NEW MEXICO
HEALTH AND ENVIRONMENT
DEPARTMENT

RE: NM752124454, Revised Sampling and Analysis Plan

RE: Draft Remedial Investigation Report from Cannon Air Force Base
EID File # 397 ER

RE: Installation Restoration Program: FPTA-4, Site 9 Tank Removal
EID File # 405 ER

Figure 109

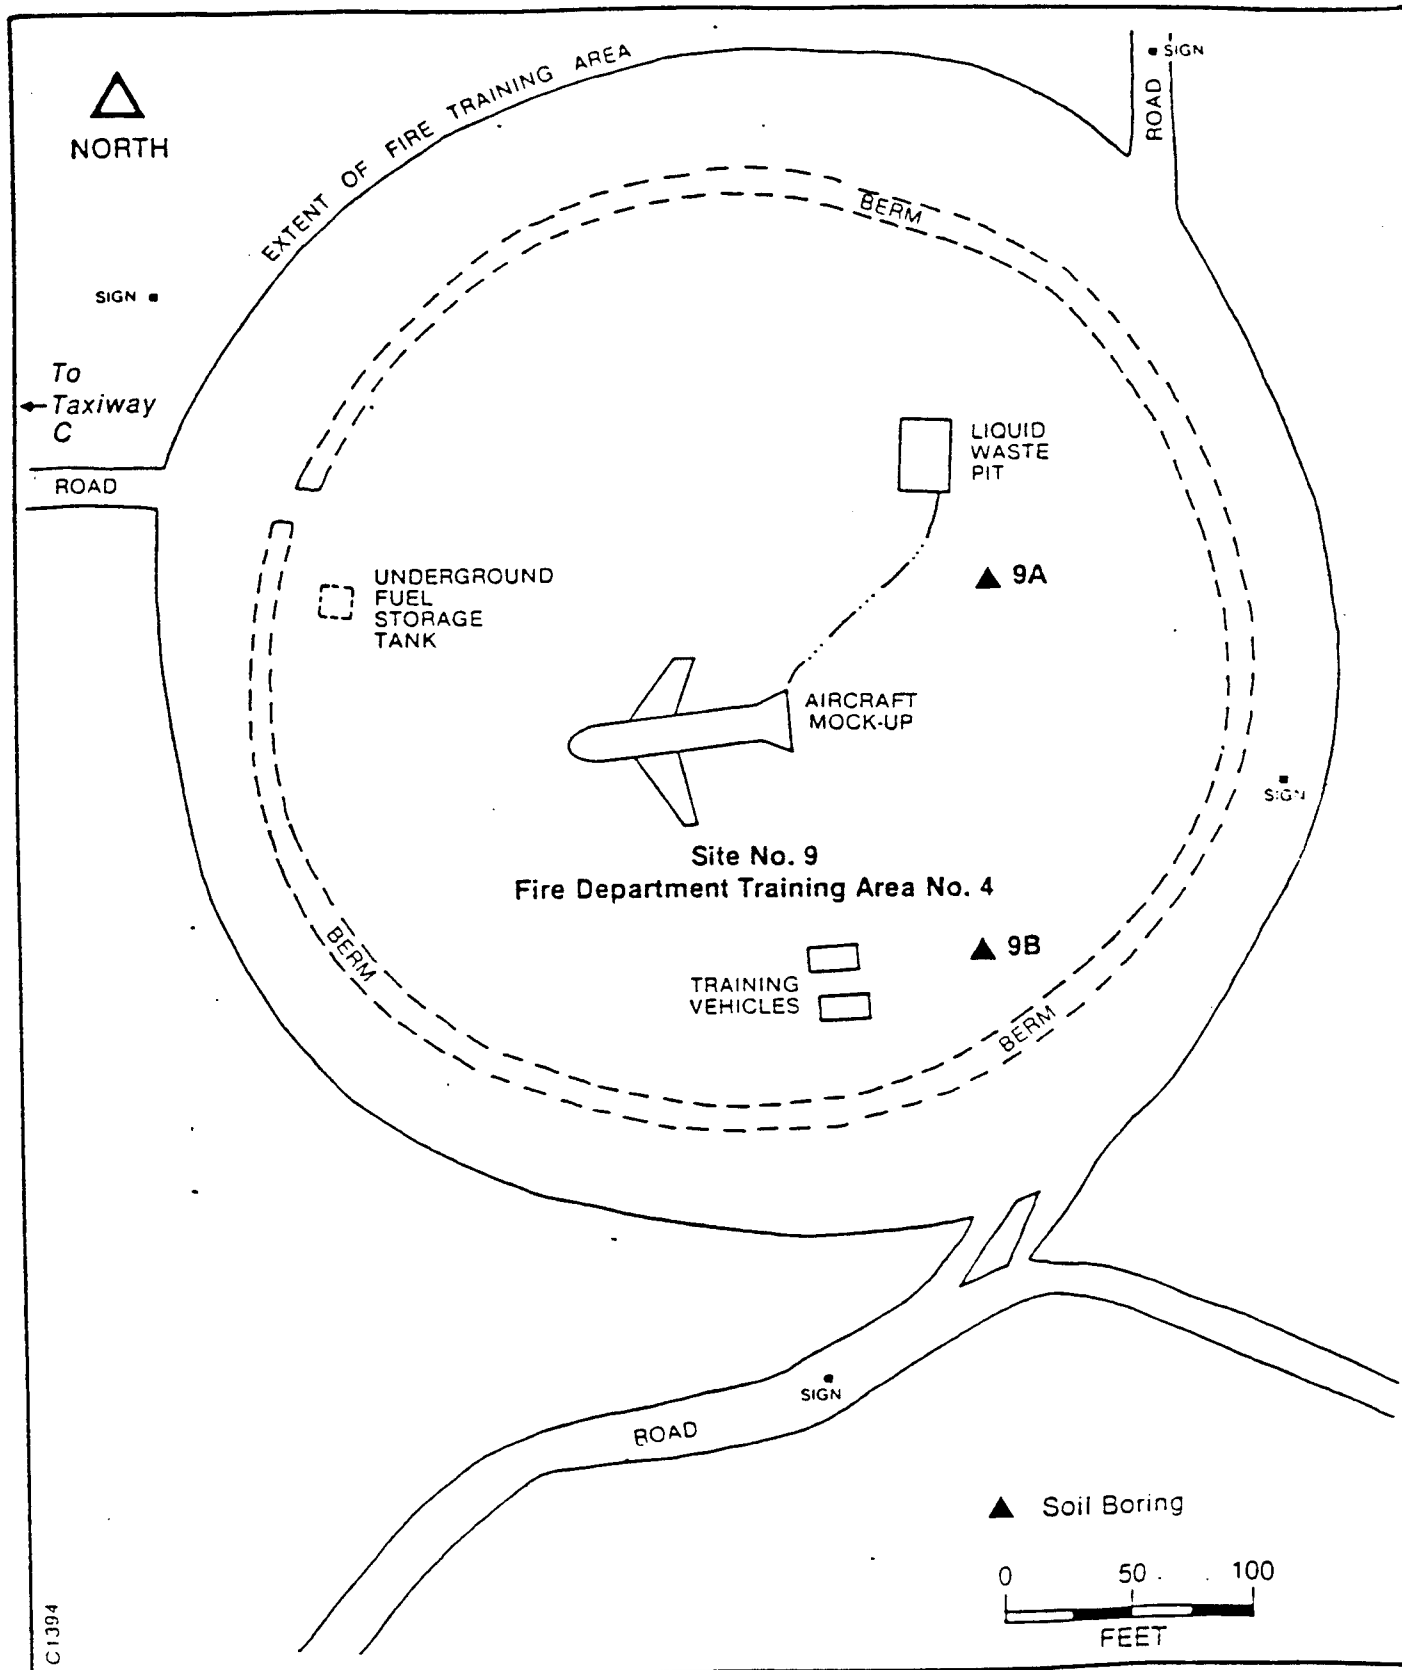
This unit was addressed in the July 28, 1988 correspondence regarding CAFB's Draft Remedial Investigation Report, EID File # 397 ER. Site 9: Underground Storage Tank Runoff at FPTA-4 is identified as Solid Waste Management Units (SWMU's) 109 and 110 in the Preliminary Review Report by A.T. Kearney. Copies of the pertinent pages from the July 28th correspondence are attached. The concern I have regarding this work proposal is the extent of excavation. On pages IP-2 and 2C-1, it is stated that the soils will be excavated to at least a depth of 5 feet. Previous sampling at FPTA-4 revealed high levels of oil and grease and lead at 10.5-11.5 feet (page 6-149 of attached papers). Also, "The excavation shall extend horizontally from the tank until the soil is visually clean (page IP-2)." Do they know the extent of the contamination vertically and horizontally and are they excavating enough?
